CITY OF PORTSMOUTH, NEW HAMPSHIRE

ADDENDUM NO. 2

PRIMARY CLARIFIER AND GRAVITY THICKENER REPLACEMENT

BID NO. 03-15

2M-2 Aerated Grit Chamber Plans, Sections & Details

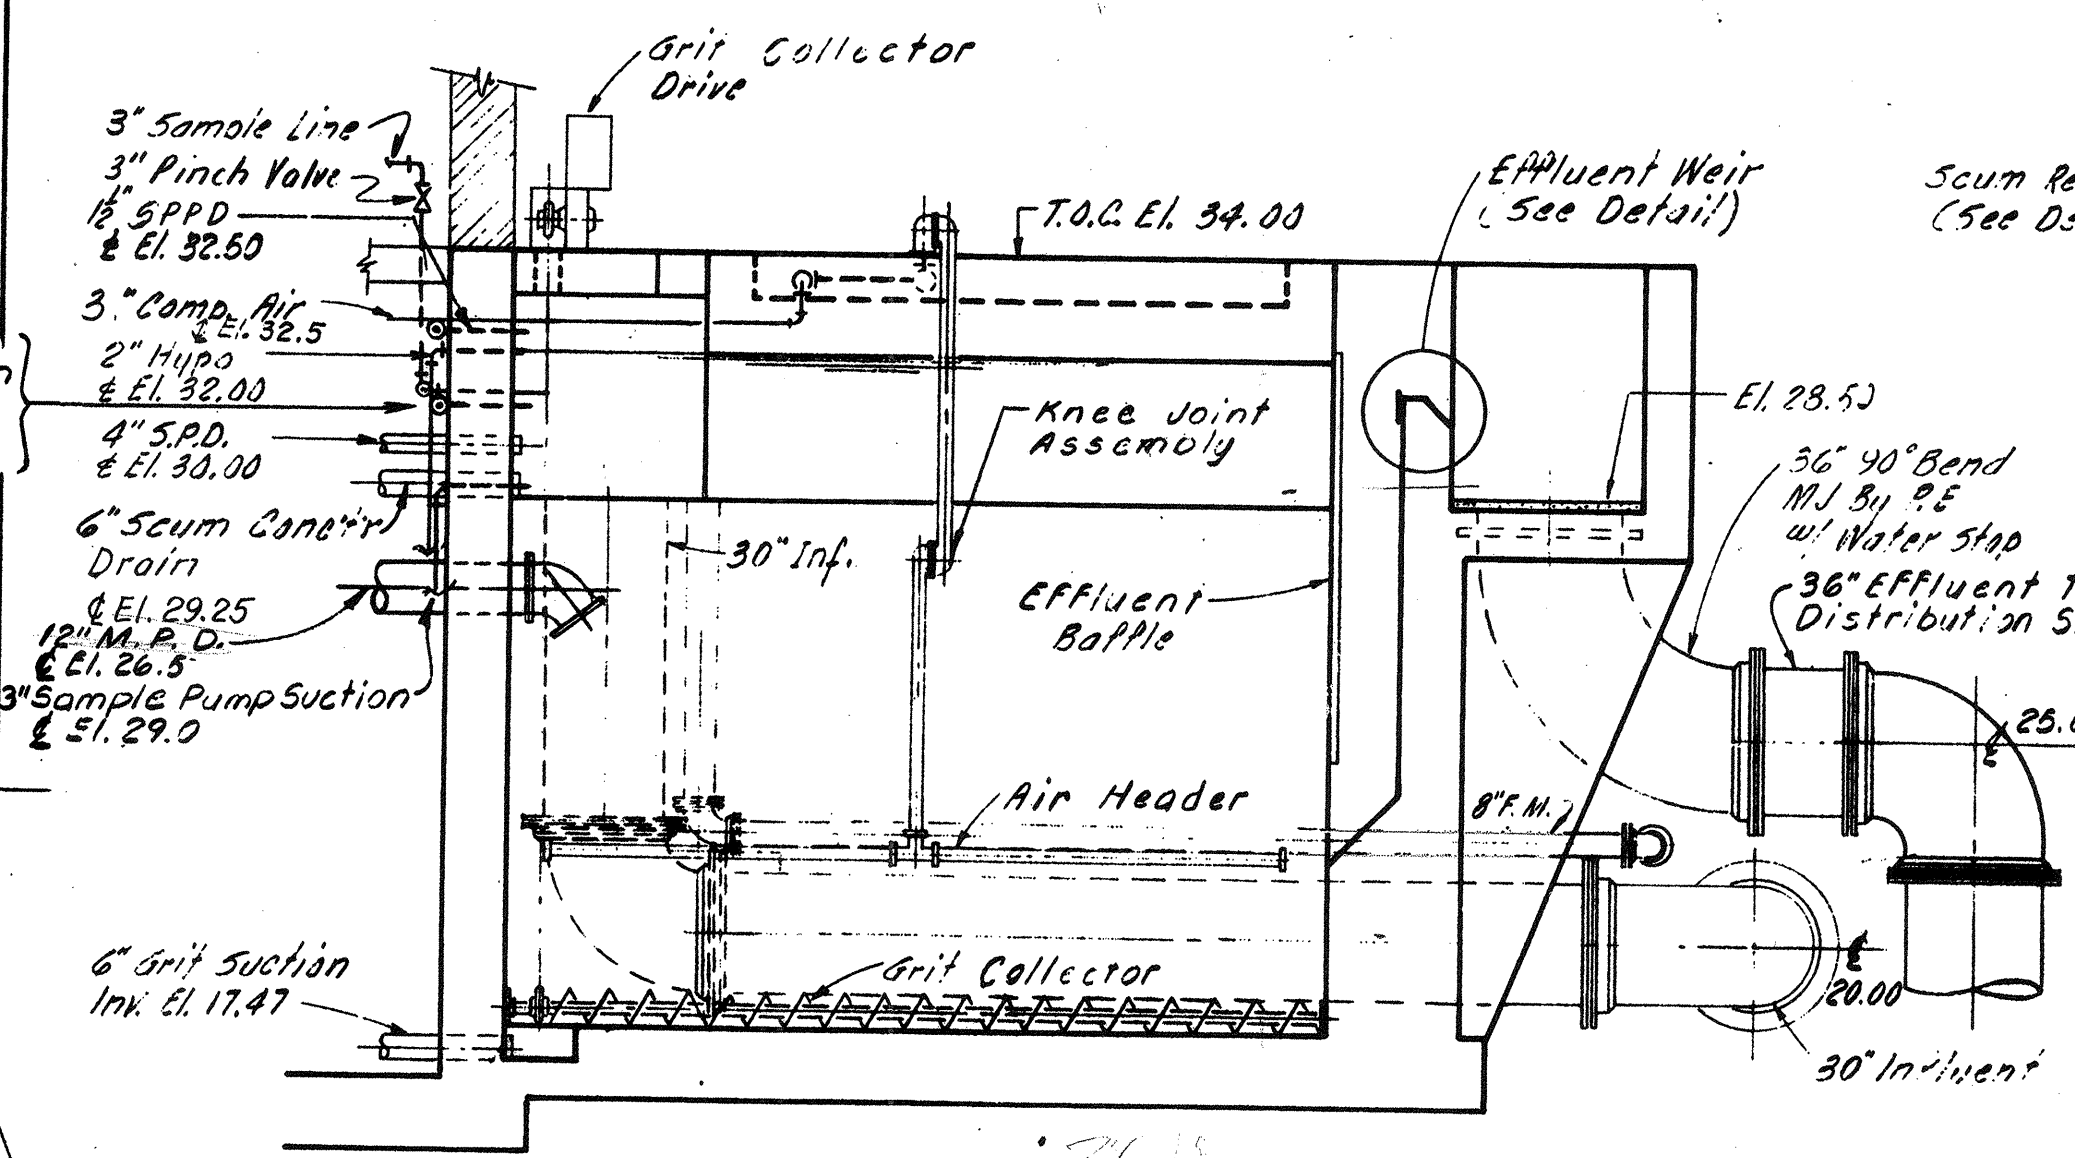
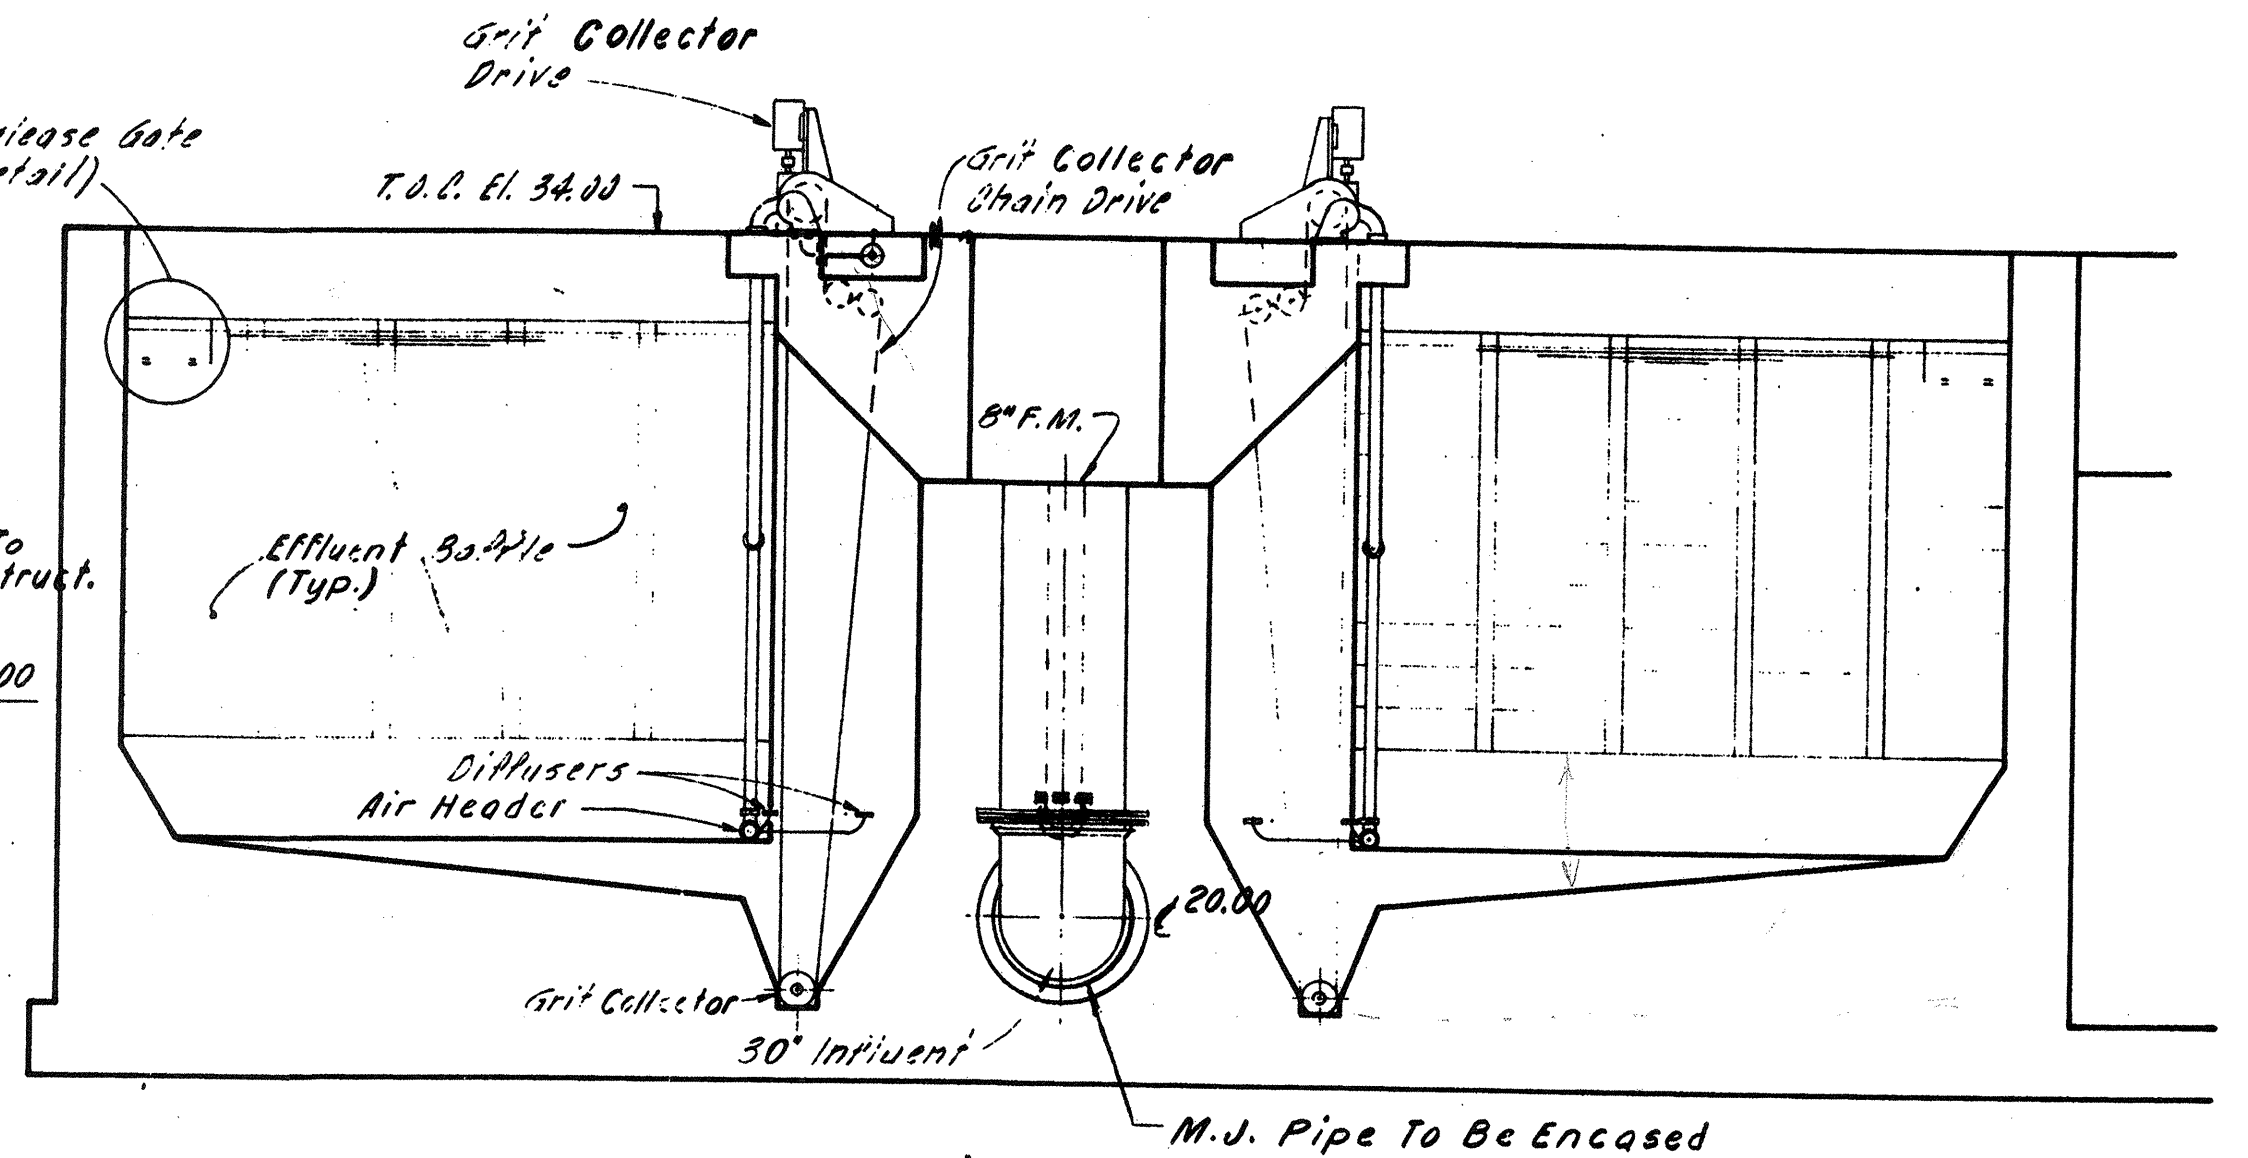
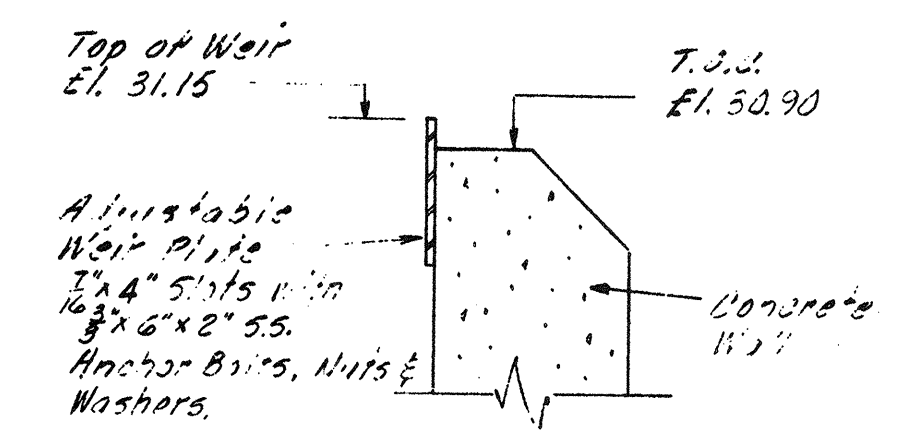
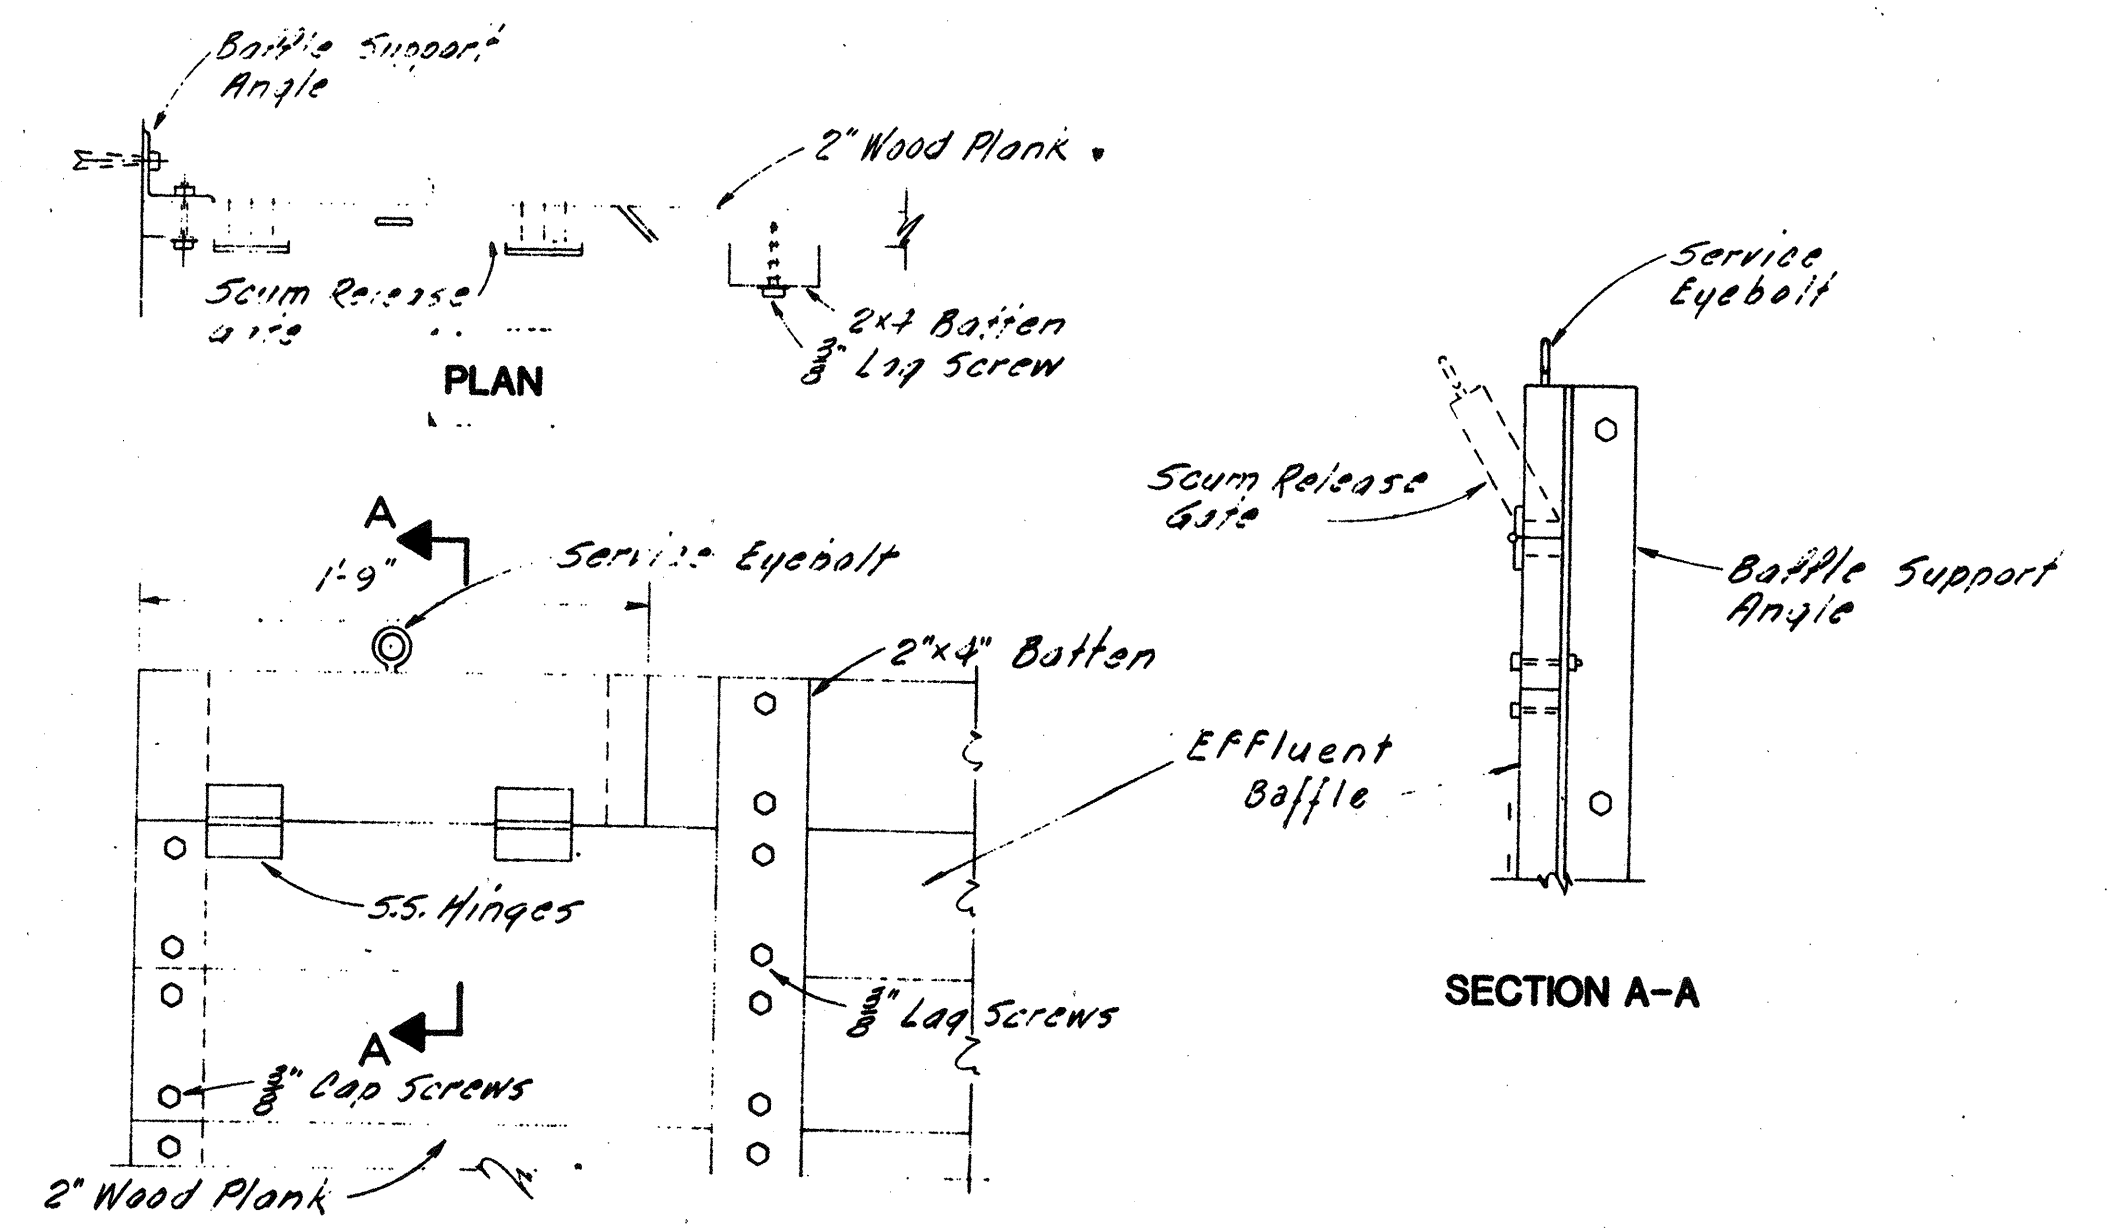
- 1. Insert the attached drawing “2M-2 Aerated Grit Chamber Plans, Section & Details” as Appendix E.
